**Request**  
**Project Name**  
**Council District**  
**Requested by**  
**Staff Reviewer**  
**Staff Recommendation**

**DTC Modifications**  
**Nashville Yards Signage**  
19 – O’Connell  
Joe Bucher, with Gresham Smith;  
Hammer  
*Approve with conditions, deferral without all conditions.*

## Downtown Code DRC Meeting of 2/10/2020

**Figure 3: Street Facing and Non-Street Facing Activated Facades with Pedestrian Paths**

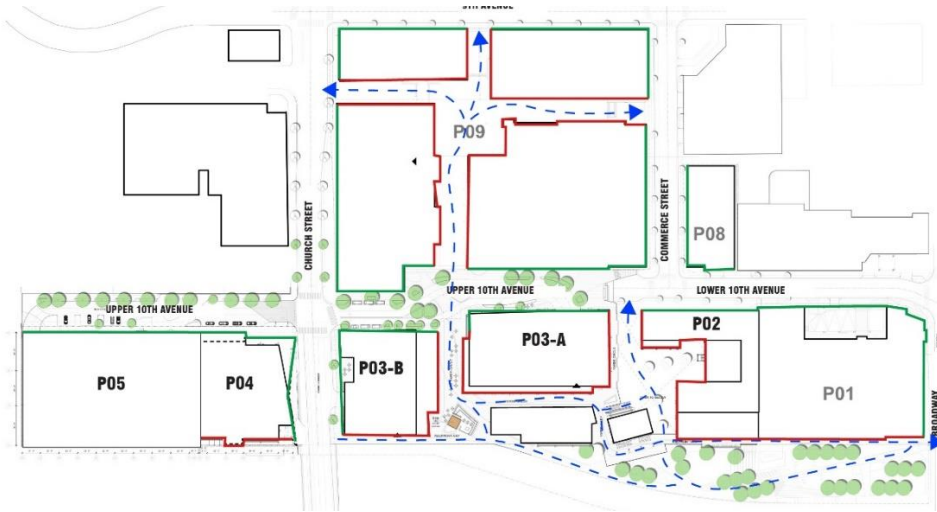
In addition to activating façades that face streets, Nashville Yards activates the pedestrian paseo that flows through the site with pedestrian-only space lined with active uses. Figure 3 below shows this condition, with activated non-street facing façades shown in red and internal pedestrian flow shown in blue. Several non-street-facing façades within Nashville Yards feature two levels of activated space facing walkways or other pedestrian spaces, which essentially doubles the signage on a façade that is allocated half of the typical entitlement for façades facing streets.

**Figure 4: Locations and Orientation of Skyline Signage within Nashville Yards**

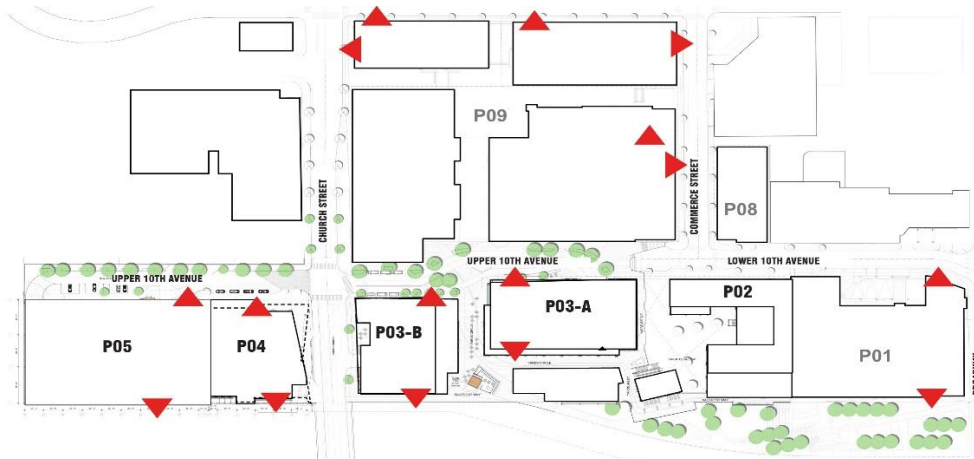
The proposed sign package seeks to transfer the skyline signage entitlements from the entitled façades facing streets to more visible non-street facing façades particularly on the west side of the site along railroad right-of-way, as indicated on Figure 6. the package also proposes allowing the towers on Parcel 3a and 5, which only have frontage on 10<sup>th</sup> Avenue North, to have 2 skyline signs where each would typically only be allowed 1. The maximum area of individual skyline signs is determined by the height of the building. All parcels are compliant with the number of entitled skyline signs, except:

Allowed	Proposed
<b>Parcel 3a: Office / Retail</b>	1	2
<b>Parcel 5: Amazon Operations II</b>	1	2

Overall, the site is entitled to 17 skyline signs and is proposing 16.

1. Skyline signs affixed to the conceptual tower on Parcel 3a and both conceptual towers on the western portion of Parcel 9 shall conform to the sign area allowed for each building's final height.
2. Modifications approved to allow digital signage shall terminate if the subject sign is moved from the placement specified by this common sign package.
3. All other standards associated with the use of digital signs, including brightness and duration must be followed.

**Figure 7: Wayfinding Sign Locations and Example Imagery**

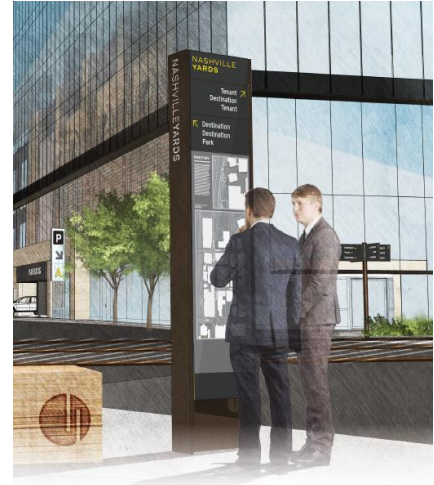
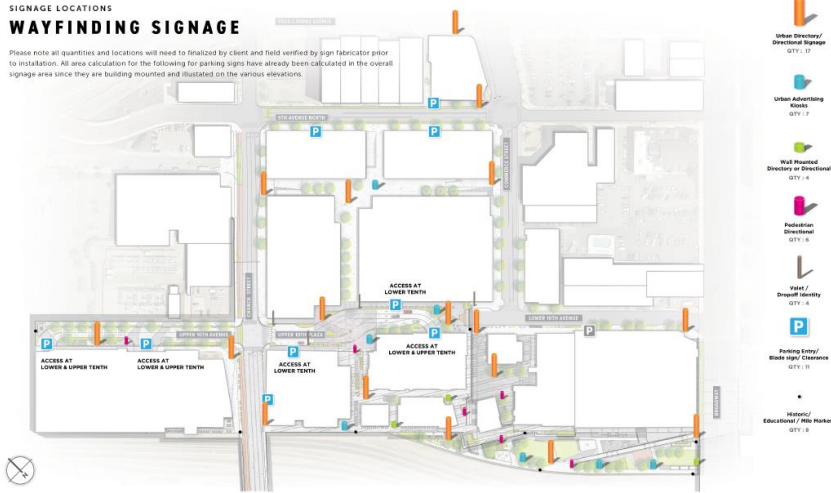
As described previously, the DTC allows monument signs and places several limitations on them. Along Transitional Streets, it limits the size of monument signs to 32 square feet and limits the height of the signs to 10 feet. One monument sign is permitted per one street frontage, unless the frontage exceeds 300 feet, in which case a second is allowed. Monument signs must be spaced a minimum of 200 feet apart when co-located along the same street frontage and a setback of 5 feet must be applied in certain cases.

In this case, this monument signage is not being proposed for specific business identification, but generalized wayfinding and environmental branding. Proposed signage along streets is oriented to pedestrians and is constructed with durable materials that reinforce the sense of place within the Nashville Yards site. The proposed signs range from approximately 4 feet to approximately 12 feet.
